# Memo

**To:** Patricia Davis, P.E., Brad Marshall  
**From:** Jonathan Tran, P.E., Ron Mick, P.E.  
**Copy:** Matt Gaughan, P.E., Charles Cameron  
**Date:** November 12, 2021  
**Subject:** CWWTP1 Change Order 0005

For the Central Wastewater Treatment Plant Expansion project, the Owner's Representative Team recommends approval of the attached Change Order 0005 in the amount of \$125,009.25 and 113 additional days to the contract with BAR Constructors, Inc. as indicated in Table 1 below.

SHEET **M-HW-3**  
SEQ. 72

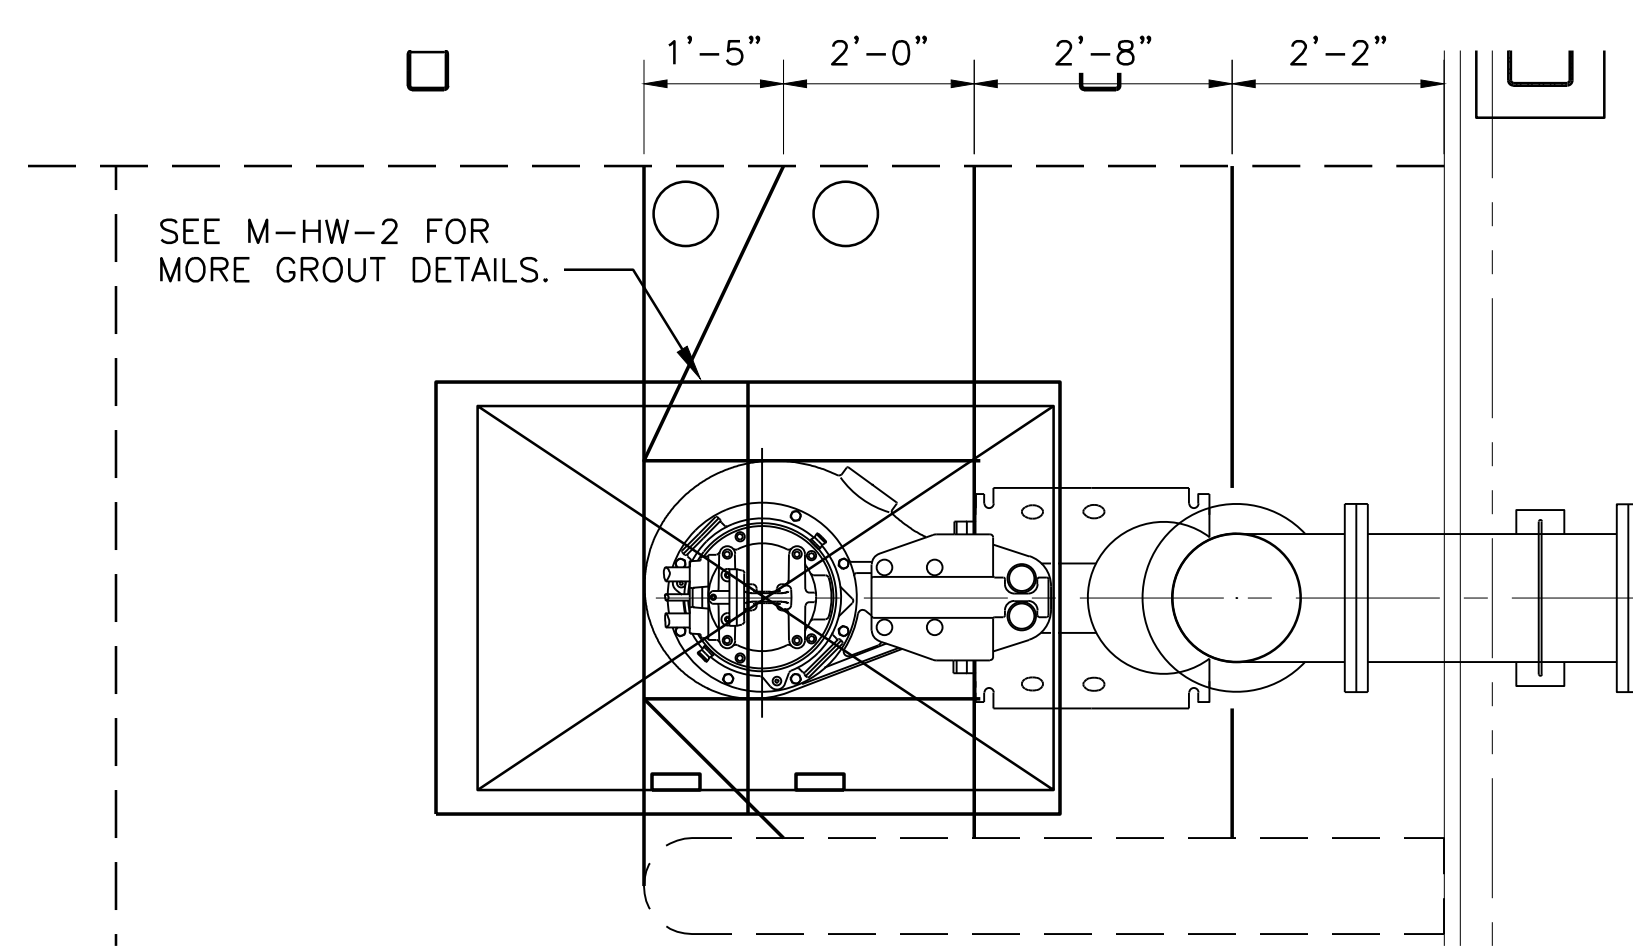
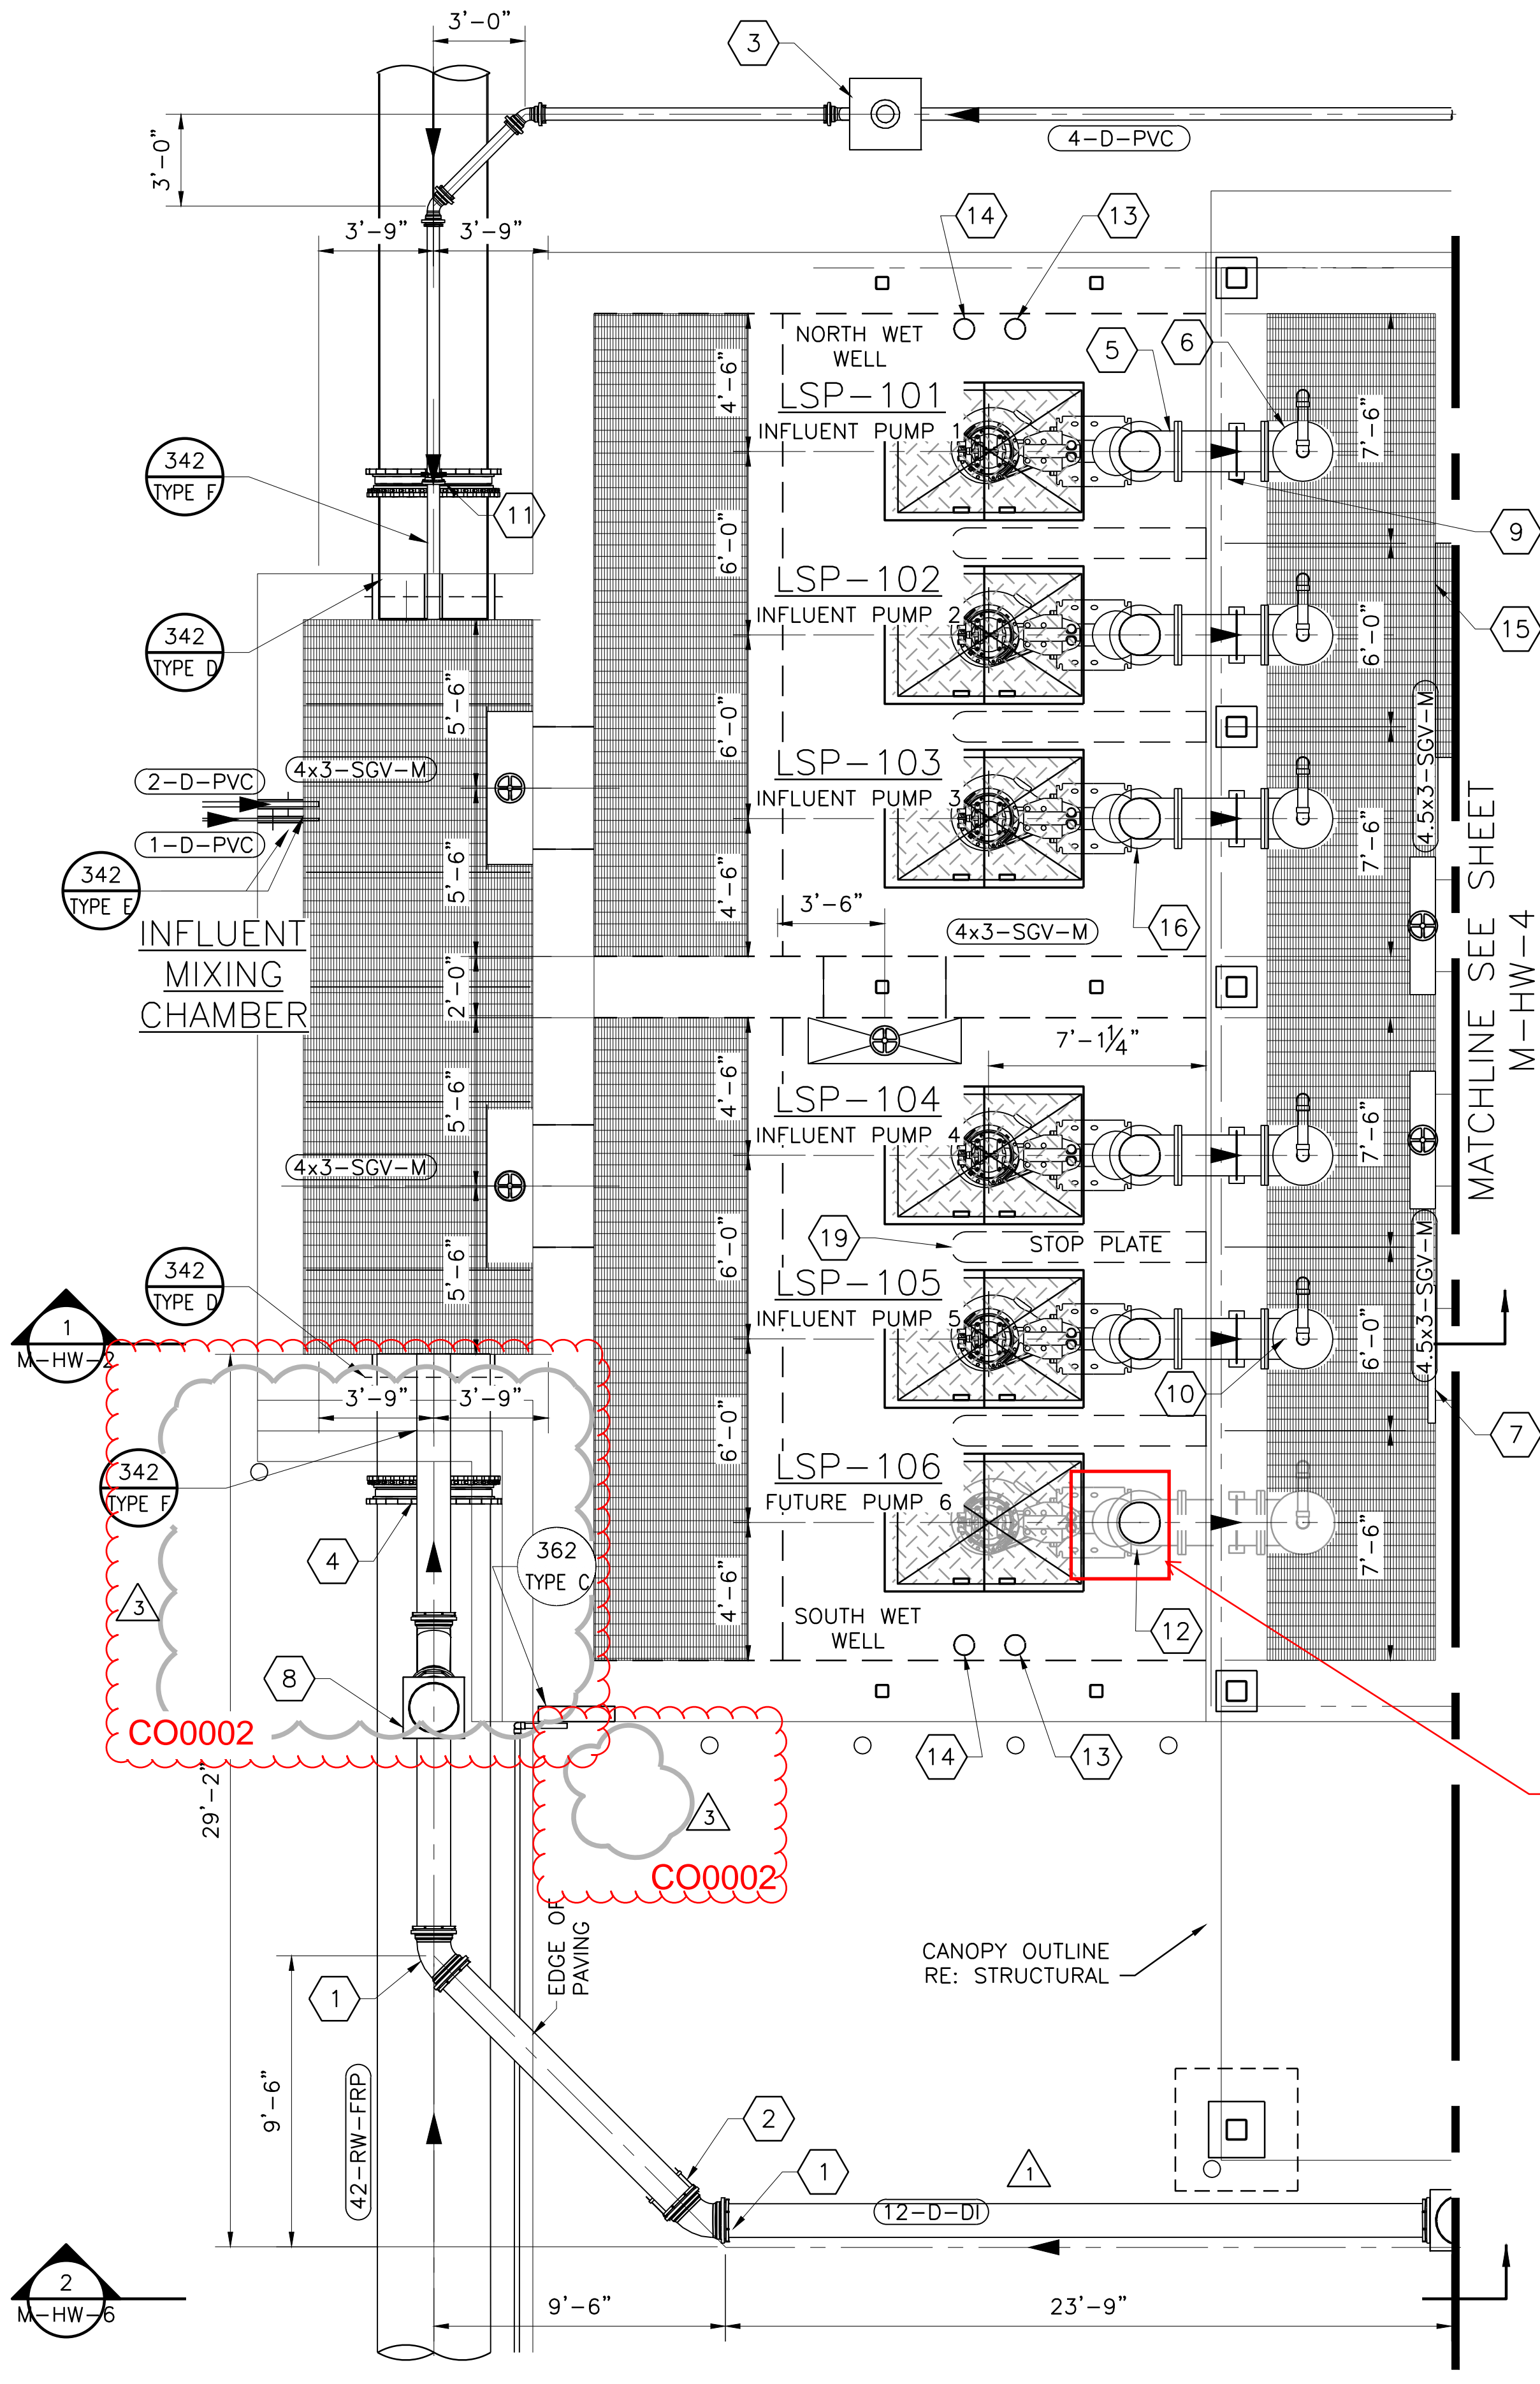
**RCP 0004**  
Eliminate Bolted Cover. Complete Pipe penetration as indicated for pumps LSP-101-105.

**RCP 0004**  
Provide LSP-106 guide rail, base TEE, discharge piping, and pipe supports.

- Install Pump Rails, Base-TEE, and discharge piping withing the wet well for LSP-106.
- All installed components of this change are to be in accordance with submitted items for LSP-101 through 105.
- Base Tee and pump rails are to be compatible with the submersible pump that will be installed in the future and equal to those provided for LSP-101 through 105.
- Discharge piping to be ductile iron and anchored to the walls as required for LSP-101 through 105.
- Continue discharge piping to a point above the Wet Well top deck and terminate with a blind Flange on the flange connection for the future flow meter.
